DATE October 21, 2020

TO John Rygh
Save the South Fork
Pete Dronkers
Earthworks

FROM Betsy Semmens, RG

I have reviewed portions of the Draft Environmental Impact Statement (*Stibnite Gold Project, Draft Environmental Impact Statement*, United States Department of Agriculture, August 2020 (DEIS, 2020, referred to hereafter as “the DEIS”)) and the following groundwater modeling reports by Brown and Caldwell (BC) to evaluate potential impacts to groundwater from proposed mining activities at the Midas Gold Stibnite mine in Idaho:

Figure 1. Most recent calibration residual using groundwater elevation data from Appendix C (SPF 2017)

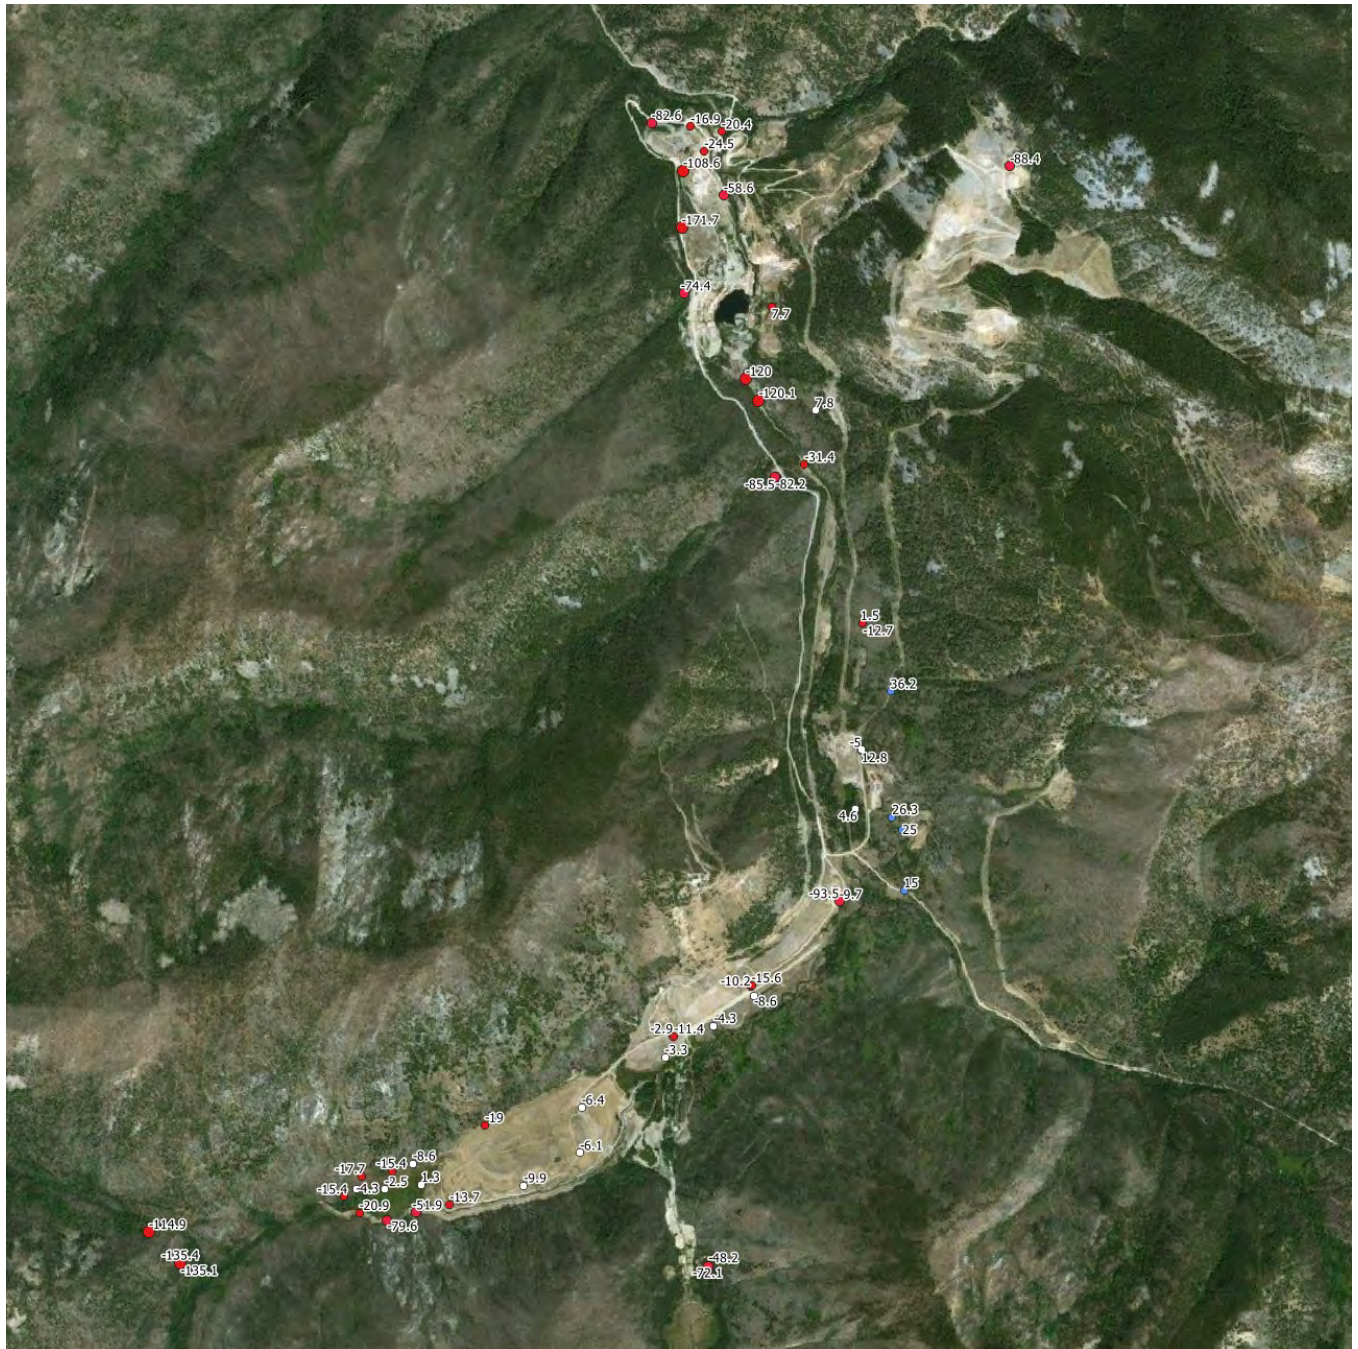
6. The transient model calibration should have been calibrated to transient groundwater elevations. As mentioned in an earlier comment, it is unclear what data were used for model calibration, however, time-series of groundwater elevations are provided in SPF 2017, Appendix C, Attachment A.

The data from Appendix C, Attachment A (SPF 2017) were input to the existing conditions model using the well construction details provided in Appendix A (SPF 2017). These groundwater elevation data are transient and were input to the model assuming that the start of the model represents January 1, 1984, as discussed previously.

The resulting calibration scaled RMS errors for the entire model, model layer 1, and model layer 2 were: 6.0%, 3.3%, and 7.7%, respectively. These statistics are significantly worse than the statistics provided in Table 5-1 and suggest that the model is not as well calibrated as indicated, particularly in the shallow bedrock. The residuals for the most recent groundwater elevation data value from this set of calibration targets is shown in Figure 1 below. A negative residual indicates that the modeled water level is higher than the measured water level, while a positive residual indicates that the modeled water level is lower than the measured water level. Figure 1 shows significant bias that the model overestimates groundwater elevations (red markers), particularly near Yellow Pine pit and upgradient from Hangar Flats. In other words, the model's groundwater elevations are generally too high, likely meaning that the overall K values or recharge are incorrect.

Additionally, importing the calibration targets (monitor wells) using the well screen intervals from Appendix A (SPF 2017), several of the monitoring wells imported to model layers other than as indicated on Figures 5-4 and 5-5 of the modeling report (BC 2018a). Note that the model layering was not changed from that provided in the model files – the monitoring wells were simply imported to the provided model file using the coordinates and screen intervals provided in Appendix A (SPF 2017).

This shows that the model calibration presented in the modeling report (BC 2018a) is a) not as good as presented, and b) suspect because it is not able to be verified. Therefore, the validity of using this model for predictive purposes is uncertain.

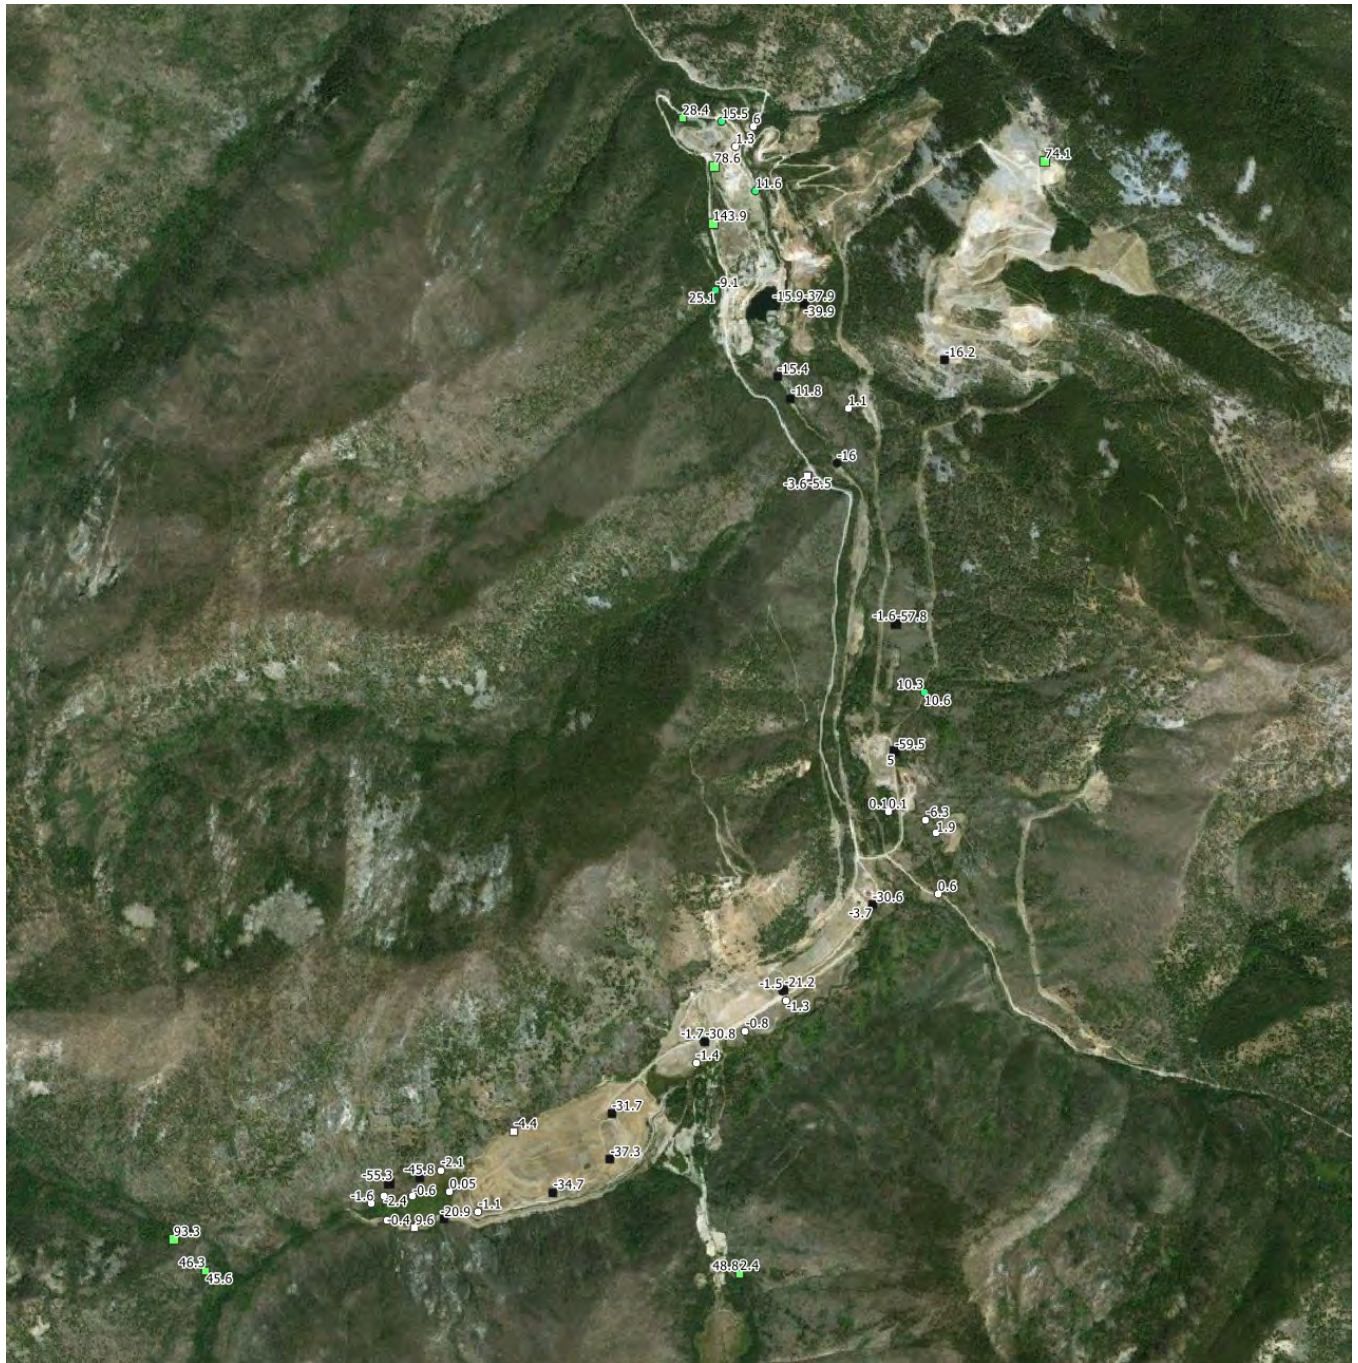
The model calibration is improved, overall, for both CA tests compared to the provided model calibration, particularly upgradient of Hangar Flats pit and near Yellow Pine pit. The difference in the absolute calibration residual for CA Test 1, for the most recent data value for each monitor well, is shown on Figure 2, and for CA Test 2 on Figure 3. A green marker indicates an improvement to the calibration, black indicates worsened calibration, and white indicates that the residual is within 10 feet of the provided model calibration. Additionally, model layer 1 residuals are represented with circles and model layer 2 with squares, and the labels are the amount the absolute residual changed from the provided model calibration (positive = improved).

Calibration residuals are unchanged (within 10 feet) or improved for all wells for CA Test 2 (Figure 3), while they are improved for wells near Yellow Pine pit and upgradient of Hangar Flats for CA Test 1 (Figure 2). The resulting calibration statistics were improved for both CA tests compared to the provided model calibration, particularly in the shallow bedrock (model layer 2). These statistics are summarized here:
